ADDENDUM NO. 03

Date: July 23, 2025

Project: Package C – Wastewater Treatment Plant Improvements
Wynne, Arkansas

The Contract Documents dated June 2025, are hereby amended as follows:

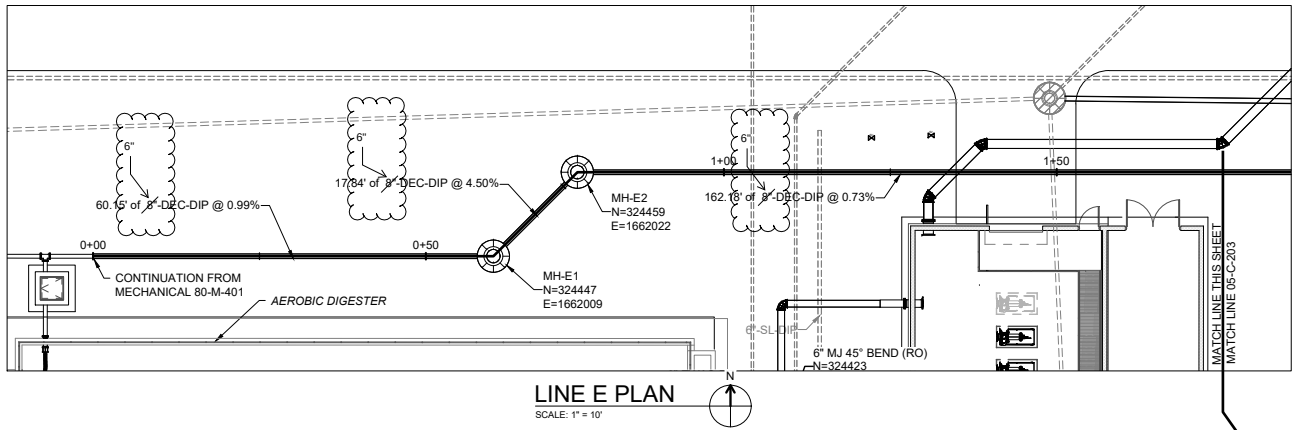
Item 2 – 05-C-103 – Land Application Layout Plan

6" Plug Valve in accordance per specification section 331216

GRIT REMOVAL
UNDER SLAB DRAIN PIPING PLAN
N.T.S.

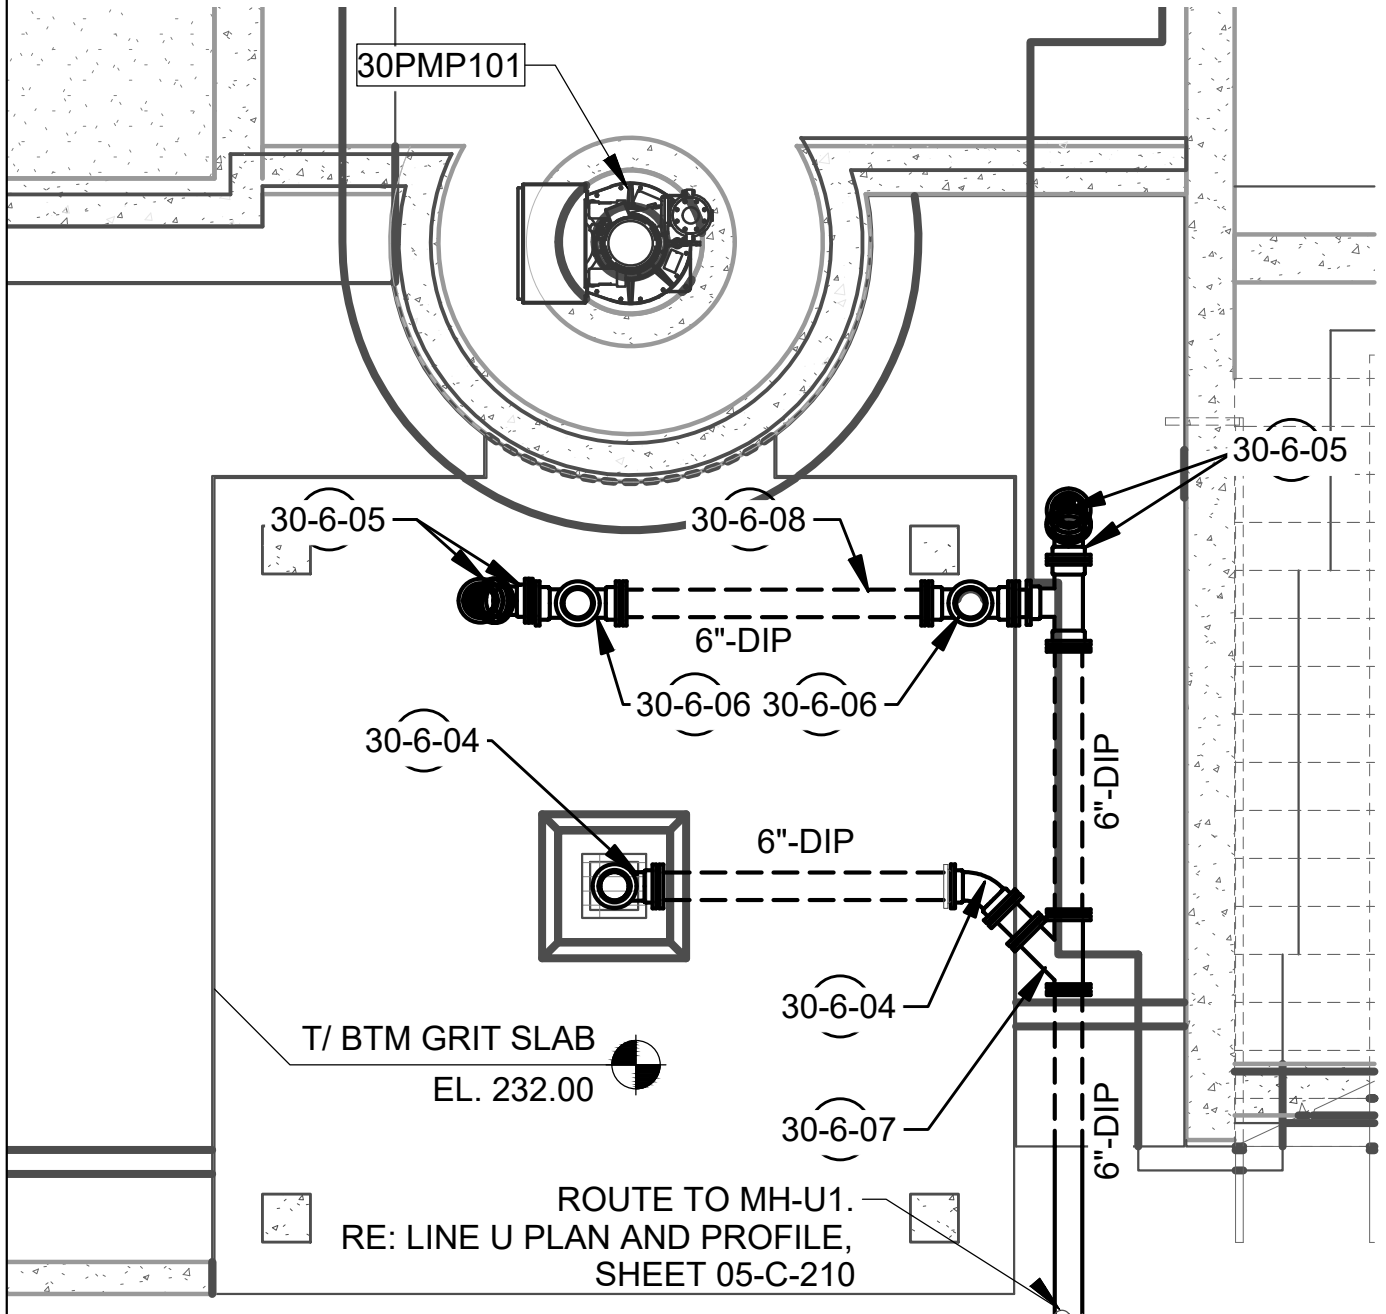
Item 6 – 30-M 101 – Grit Removal Plan

30-PIPING MATERIAL SCHEDULE (ADD NO. 3)

MARK	QTY	SIZE (IN.)	CONNECTION	DESCRIPTION
30-6-04	1	6	MJ x MJ	DI 90° BEND AWWA C153
30-6-05	4	6	MJ x MJ	DI 45° BEND AWWA C153
30-6-06	3	6	MJ x MJ x MJ	DI TEE AWWA C153
30-6-07	1	6	MJ x MJ x MJ	DI WYE AWWA C153
30-6-08	4	6	PE x PE	DI PIPE AWWA C150

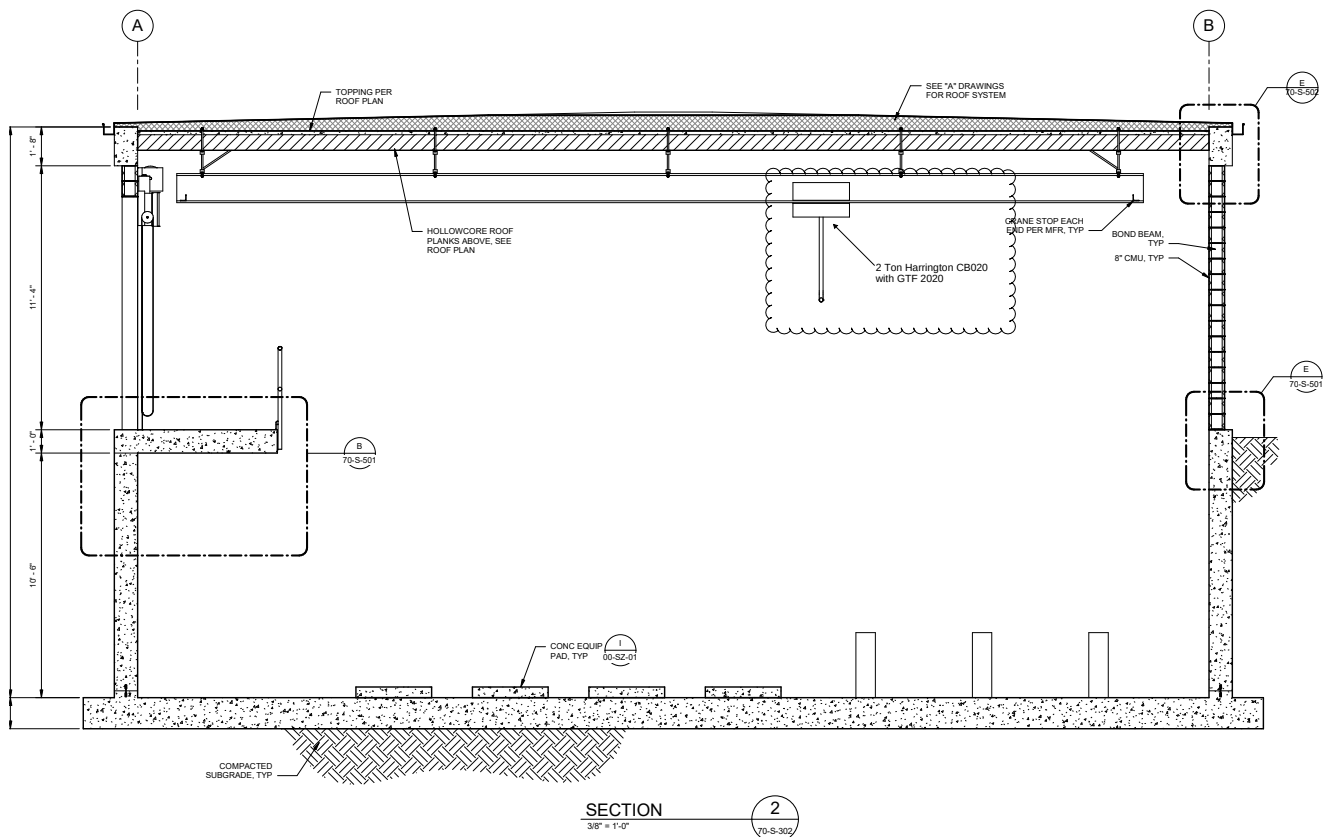
Item 8 - 70-M-101 – Pumps and Suction Piping Plan

1. RE: CIVIL YARD PIPING PLANS FOR CONTINUATION.
- ~~2. CROSS OVER STAIRS AND PLATFORM.~~
3. CONCRETE PIPE SUPPORT (RE: D / 00-MZ-04).
4. METAL PIPE SUPPORT, (RE: STRUCTURAL DETAILS).
5. FUTURE EQUIPMENT (NOT IN THIS CONTRACT)
6. SUMP (RE: B/70-M-501)

2. Cross Over Stairs and Platforms to be alternating Stair by Laypeyre Stair to be galvanized.
